Heckington Fen Solar Park

Appendix 2 – Cover Letter to the Planning Inspectorate and the Reduced Consultee List

Cover Letter

Change Notification (our document reference – PreExA.CL.CN.v1)

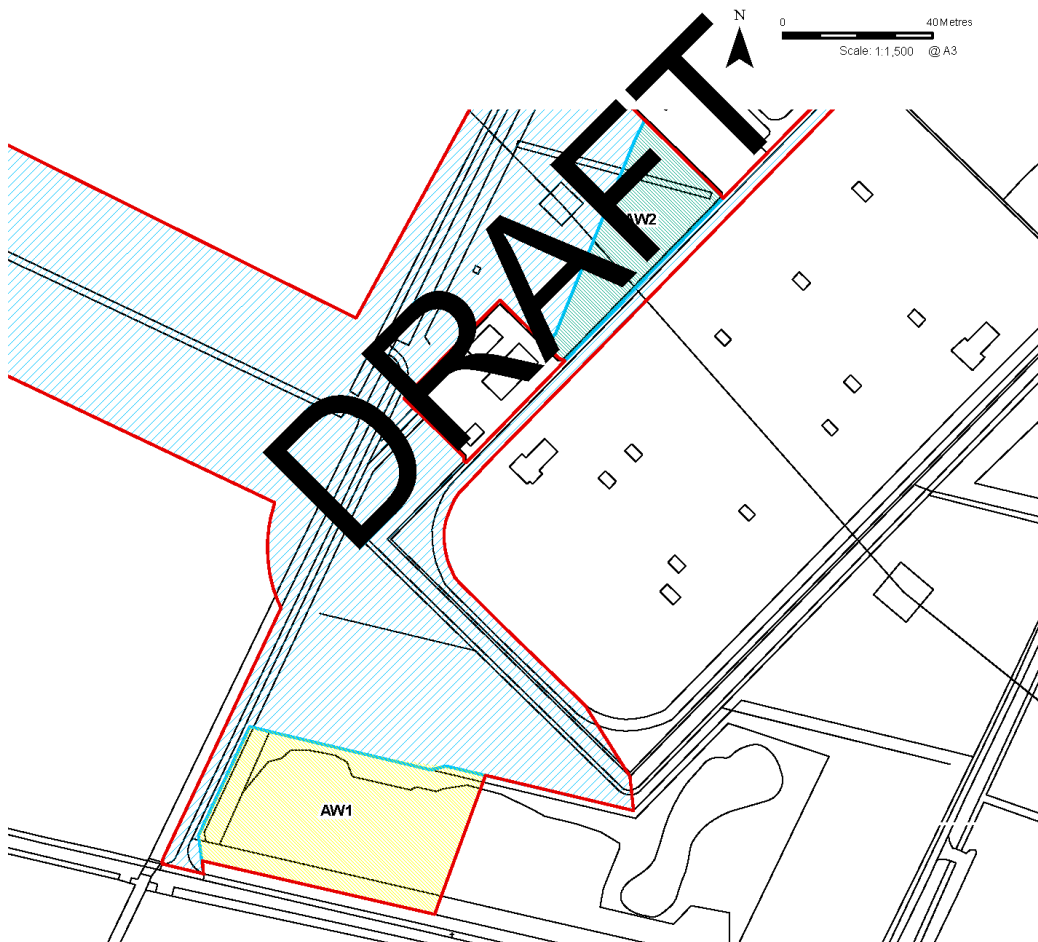
Accordingly, a larger area (of approximately 0.9ha) is needed to deliver the Additional Works and to facilitate the Applicant’s connection into the Bicker Fen Substation. The full extent of the land area covered by the change is shown in yellow and green hatching on plan overleaf.

-  Proposed Order Limits
-  AW1 extension for bus-coupler
-  AW2 extension for new CSE*
-  Accepted DCO Order Limits

Photograph taken from Vicarage Drive looking east, markers indicate approximate AW1 area

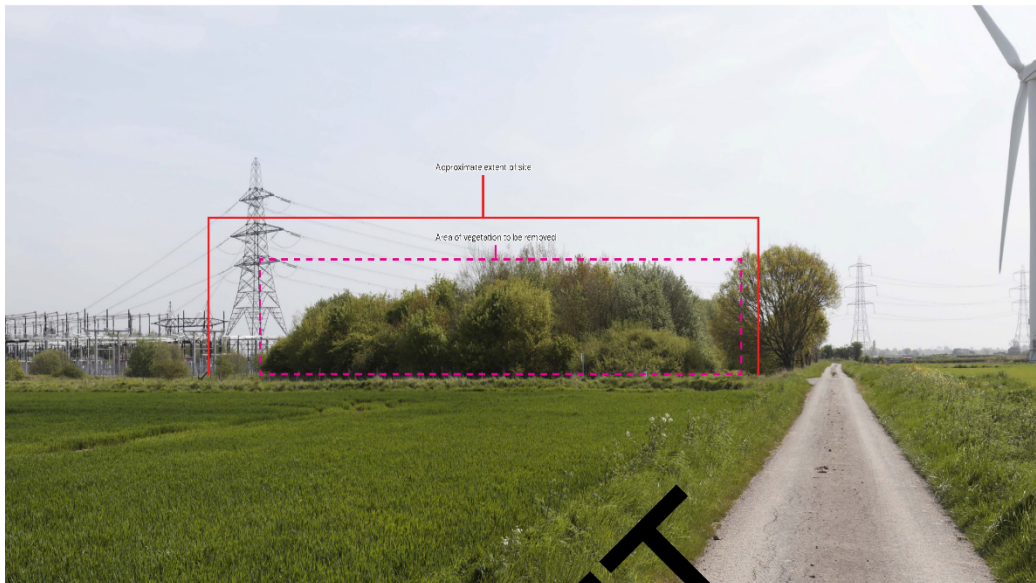
The extent of the trees which need to be cleared to enable the necessary expansion at Bicker Fen can be seen on the plan below (yellow area). NGET have advised that the tree clearance would only be required if an Air Insulated Switchgear (AIS) solution is used. This design solution would be a continuation of the switchgear equipment already in operation at Bicker Fen National Grid substation. The alternative design option is the installation of a Gas Insulated Switchgear system (GIS). This alternative solution would be housed within a building and would occupy a smaller footprint than the AIS design option.

Figure 1
Title: Change Notification
Bicker Fen

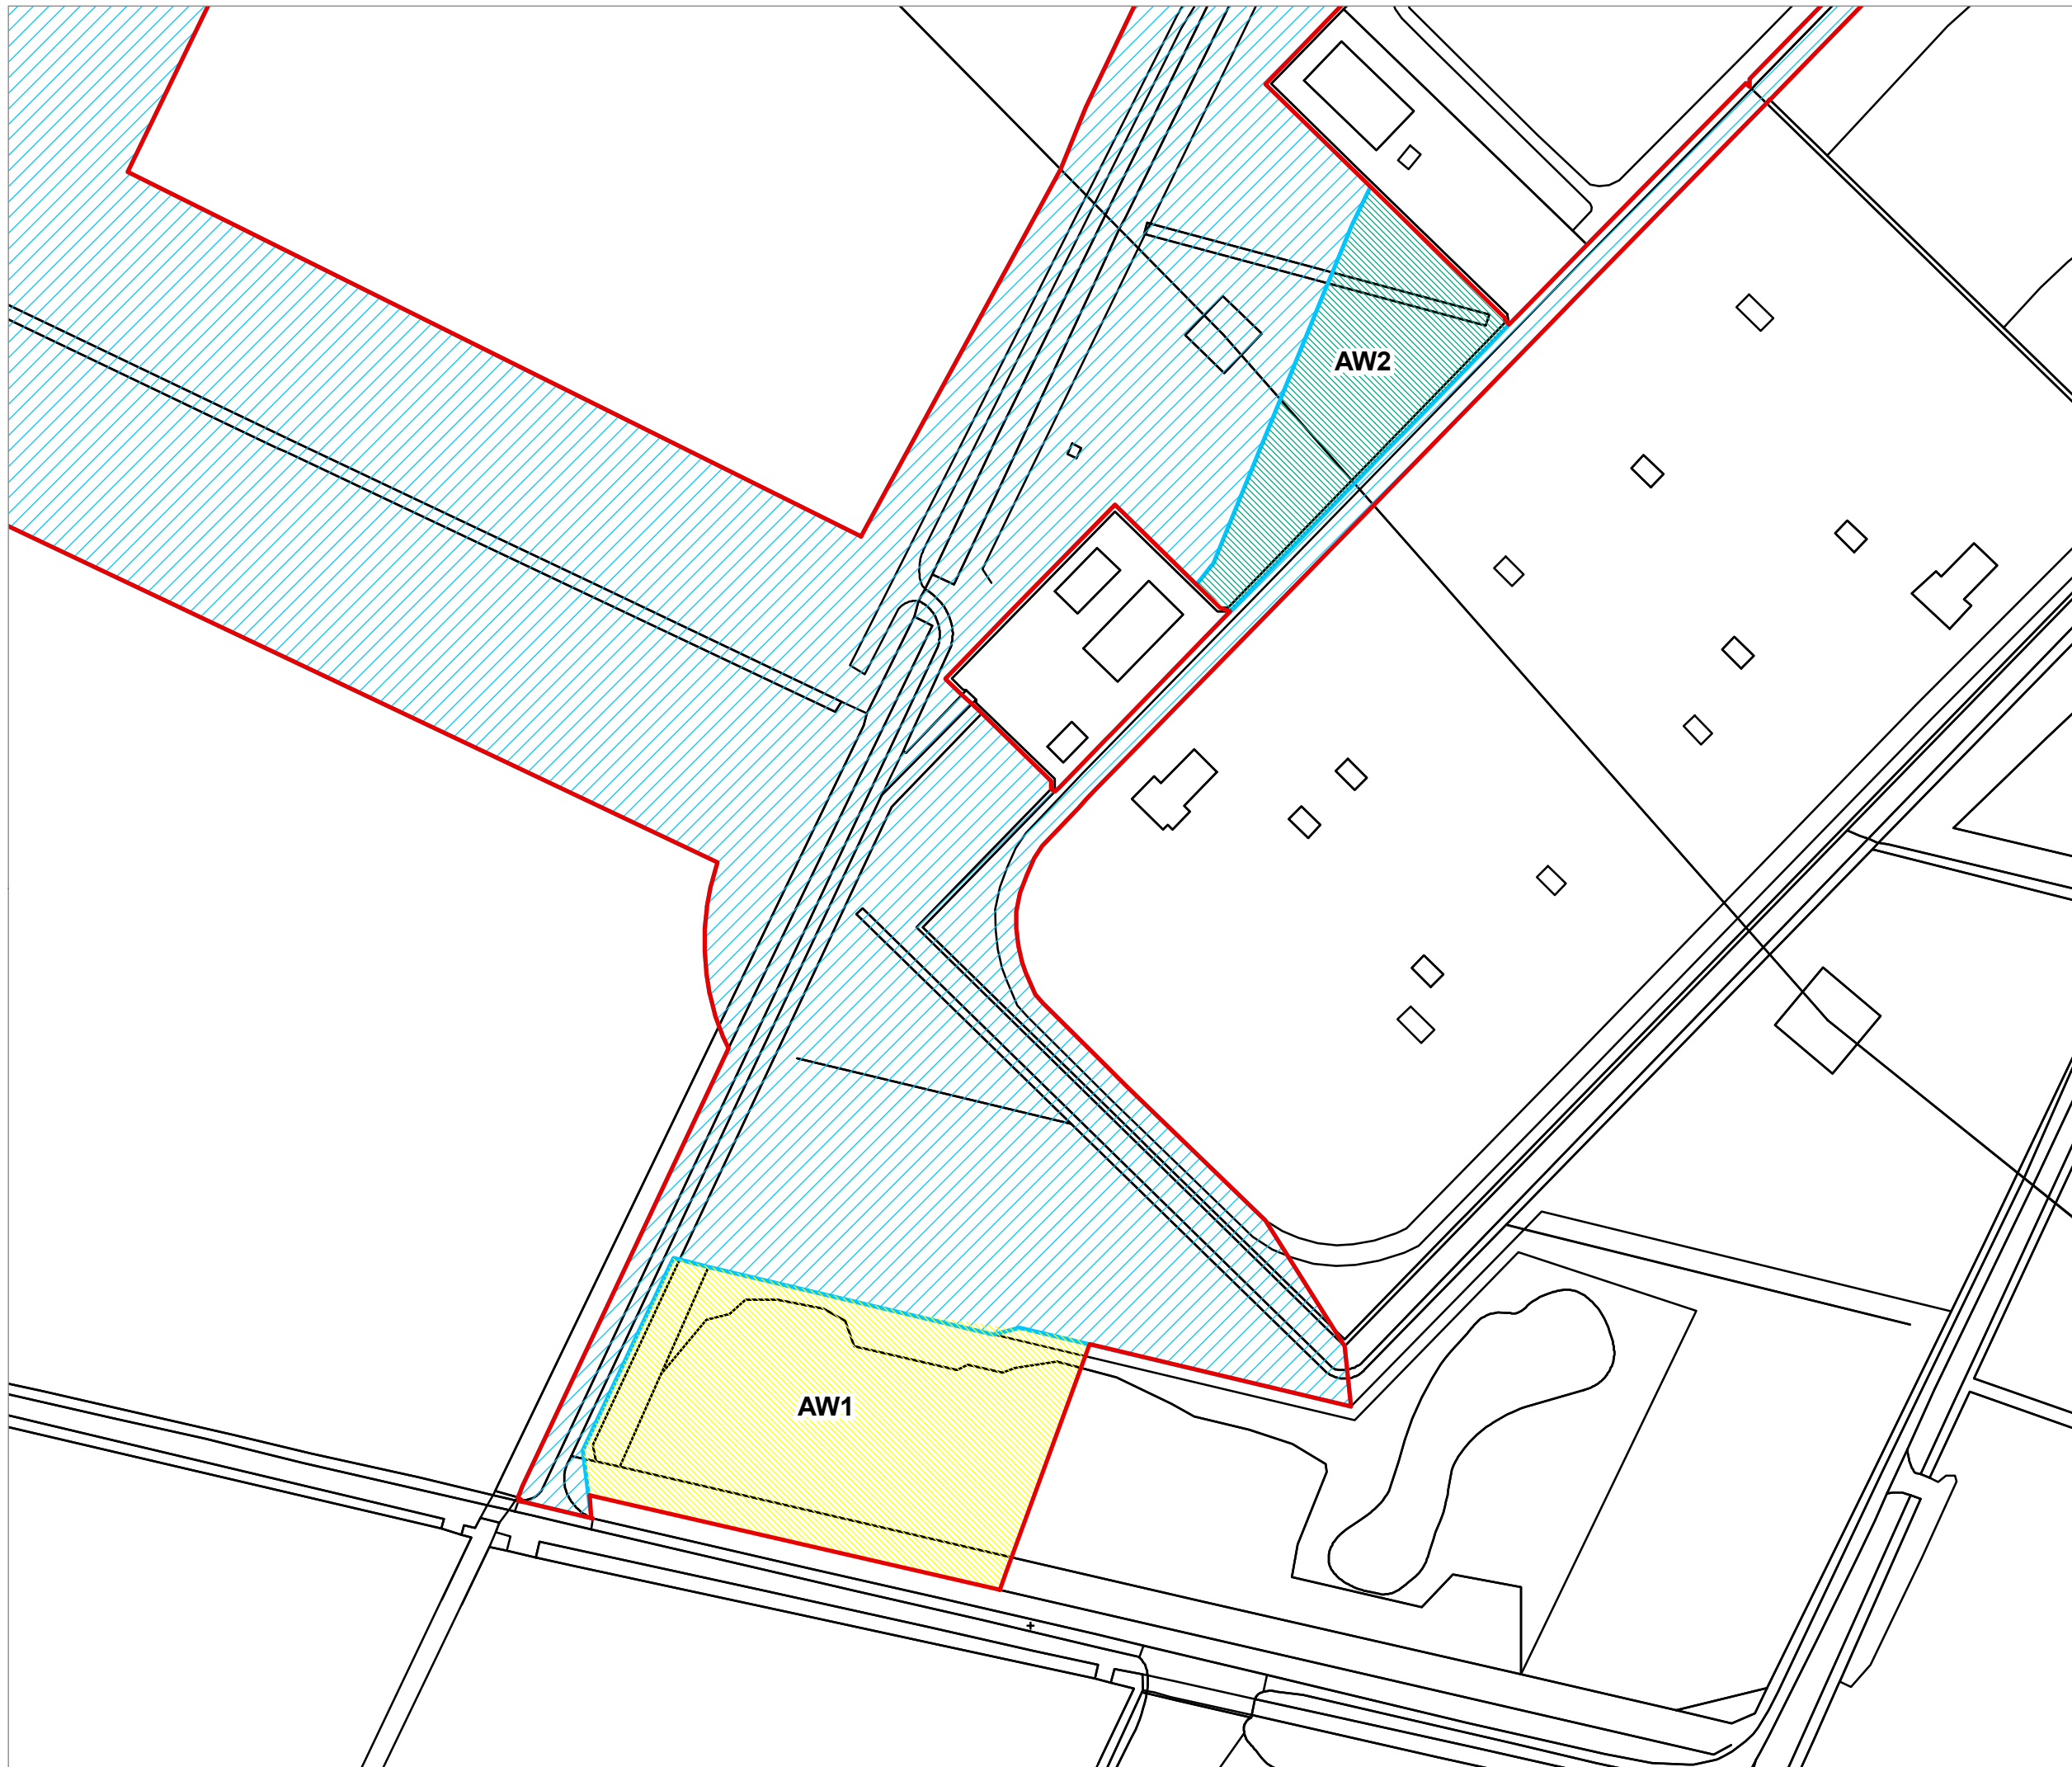
1. a new section of NGET infrastructure at the substation comprising a busbar extension including a section breaker, a bus coupler and a feeder circuit on land to the south of Bicker Fen Substation, which is owned by NGET; and
2. a new cable sealing end ("CSE") compound on land to the west of Bicker Fen Substation which is owned by NGET.

Accordingly, a larger area is needed to facilitate the Applicant's connection into the Bicker Fen Substation. The full extent of the land area covered by the change is shown in yellow and green shading on Figure 1 appended to this letter.
